# SERVICE BULLETIN

SERVICE BULLETIN NO: 32-021

MODIFICATION NO: EC 08-0766

## LANDING GEAR - NOSE WHEEL STEERING REPLACEMENT OF THE CRANK BAR ASSY

Crank Bar Assy - Removal/Installation  
 Figure 1

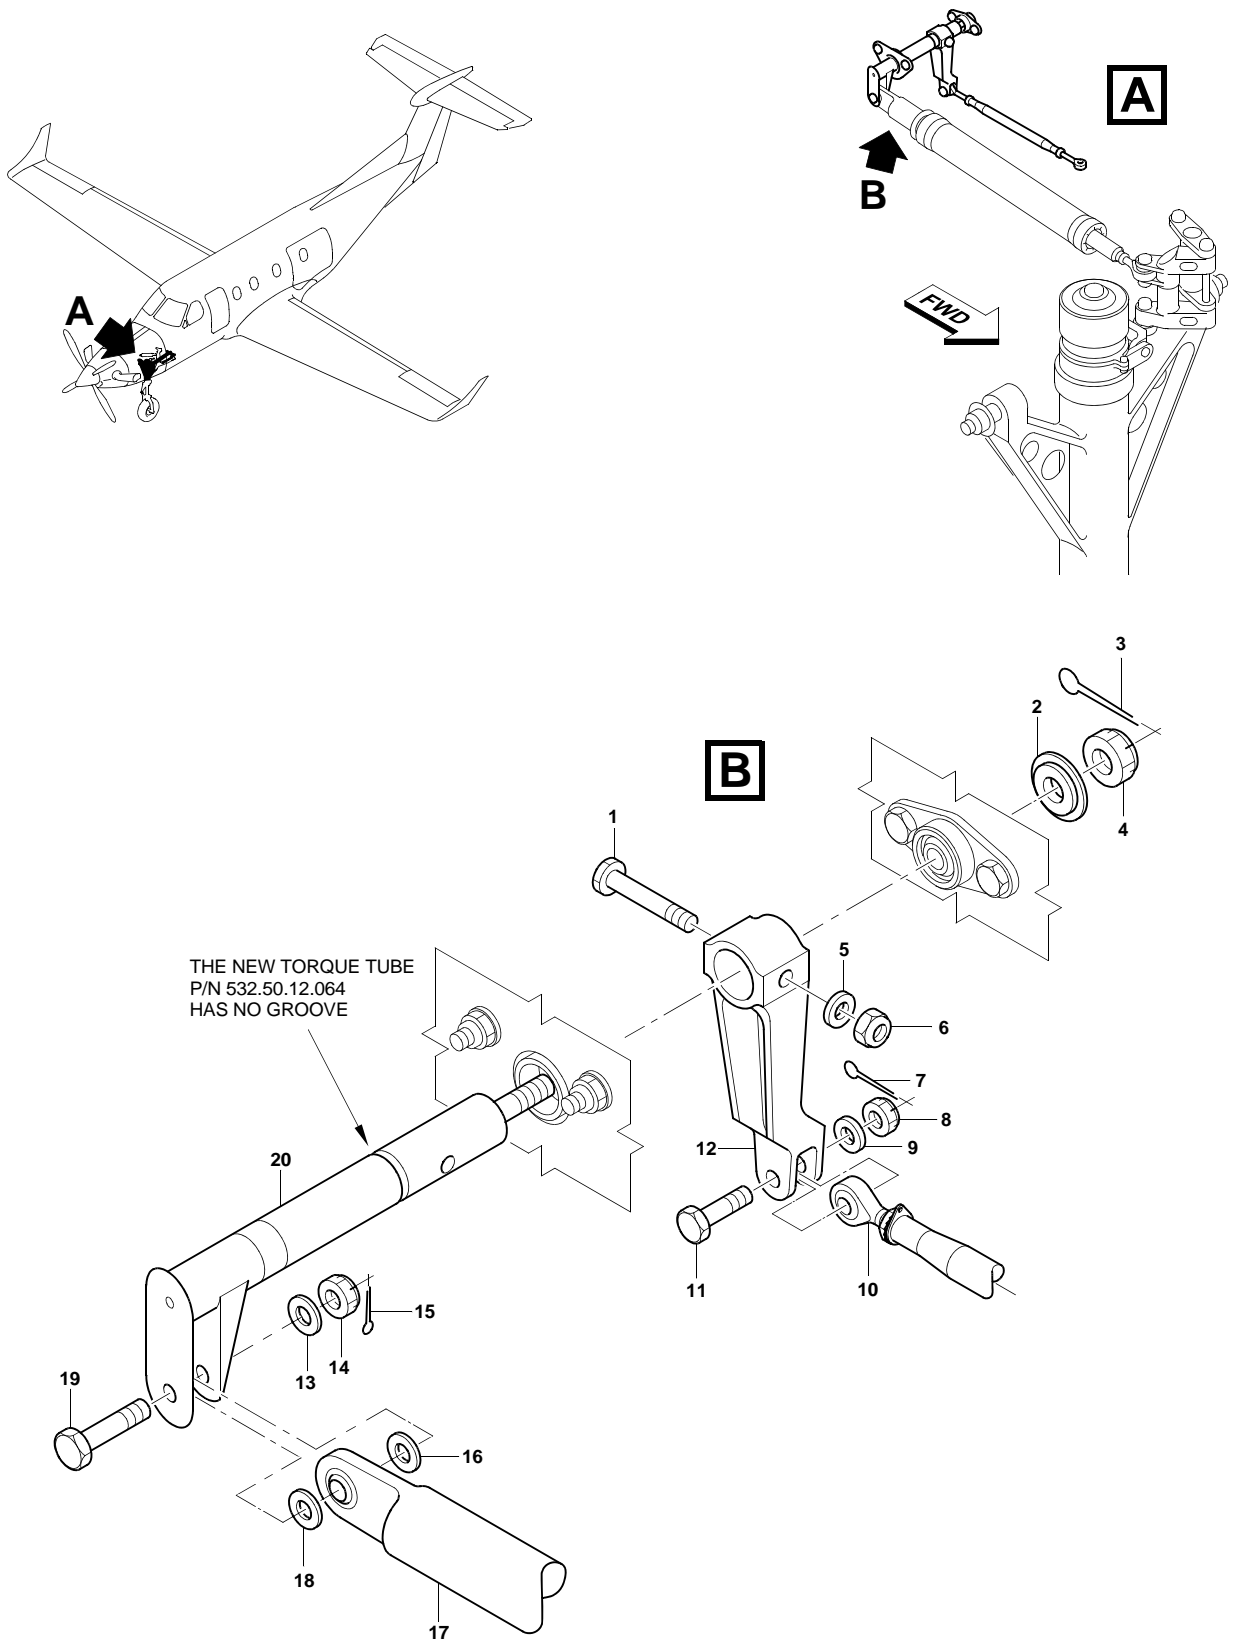
Failure of the nose wheel steering system because of fatigue cracking of the torque tube in the crank bar assy.

Some torque tubes were bored off-center during manufacture. This results in a reduced wall thickness at one side of the torque tube. The torque tube can also crack at the bolt holes for the lever attachment bolt.

Install a new crank bar assy which is manufactured to a higher standard.

HYDR CTL (NON ESSENTIAL BUS)
- (3) Make sure the nose wheel is in the neutral position and there is no load on the spring strut (17).
- (4) Open the access panel 11AL (Ref AMM.12-A-06-20-00-00A-040A-A).
- (5) If necessary, remove the Orcotape and insulation to get access to the nut (4).
- (6) Remove the cotter pin (7), the nut (8) and the washer (9).
- (7) Remove the bolt (11) and disconnect the rod (10).
- (8) Remove and discard the nut (6), the washer (5) and the bolt (1)
- (9) Make sure that the lever (12) can turn on the torque tube (20). If you cannot turn the lever (12) with your hand:
  - (a) Lower the aircraft until the nose wheel is on the ground and cannot turn.
  - (b) Use force to make the lever (12) free to turn.

**NOTE:** You can use penetrating oil to help to release the lever.
  - (c) When you can turn the lever (12) on the torque tube (20), lift the nose wheel.
- (10) Remove the cotter pin (15), the nut (14) and the washer (13).
- (11) Remove the bolt (19) and disconnect the spring strut (17). Collect the washers (16) and (18).
- (12) Remove the cotter pin (3), the nut (4) and the washer (2). Make a note of the installation position of the washer (2).
- (13) Hold the lever (12) and remove the torque tube (20) from the lever and bearings.
- (14) Keep the lever (12) and the torque tube (20) and send them to Pilatus Aircraft Ltd.

- (1) Apply a thin layer of corrosion preventative (Material No. P04-012) to the inside mating surface of the lever (12)
- (2) Hold the lever (12) (P/N 532.50.12.051) between the bearings and install the torque tube (20) (P/N 532.50.12.064). Make sure the lever (12) is installed in the correct position as shown in Fig. 1.
- (3) Install the bolt (1) (P/N 932.19.60.801), the washer (5) (P/N 938.77.11.114) and the nut (6) (P/N 938.07.68.305).

- (4) Use the absorbent paper (Material No. P02-031) and the solvent (Material No. P01-008) to remove unwanted corrosion preventative from the torque tube (20).
- (5) Install the washer (2) (in the position noted in the removal procedure), the nut (4) and the new cotter pin (3).
- (6) Connect the spring strut (17) with the two washers (16) and (18) and the bolt (19).
- (7) Install the washer (13), the nut (14) and the new cotter pin (15).
- (8) Connect the rod (10) with the bolt (11).
- (9) Install the washer (9), the nut (8) and the new cotter pin (7).
